CL163 Comment Discussion

Credo Semiconductor

Comments Overview

Figure 93C-4—Interference tolerance channel s-parameter test setup

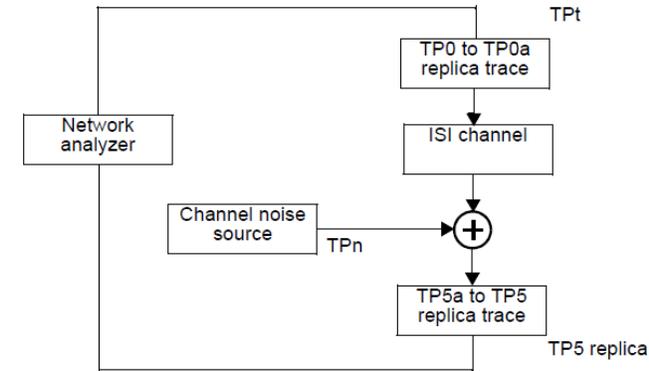
CI 163 SC 163.9.2.3 P 182 L 49 # 157

"The return loss of the test setup in Figure 93C-4 measured at TP5 replica towards TPt meets the requirements of Equation (163-2)."

Equation (163-2) is the reference return loss of a transmitter test fixture. It is irrelevant here, as the test channel at TP5 is a channel, not a transmitter.

The channel has ERL requirements, and no RL requirements.

Change the quoted sentence to

"The effective return loss of the test setup in Figure 93C-4 measured at TP5 replica towards TPt meets the requirements of 163.10.2."

PROPOSED REJECT.

For task force discussion whether RL should be replaced by ERL for replica channels.
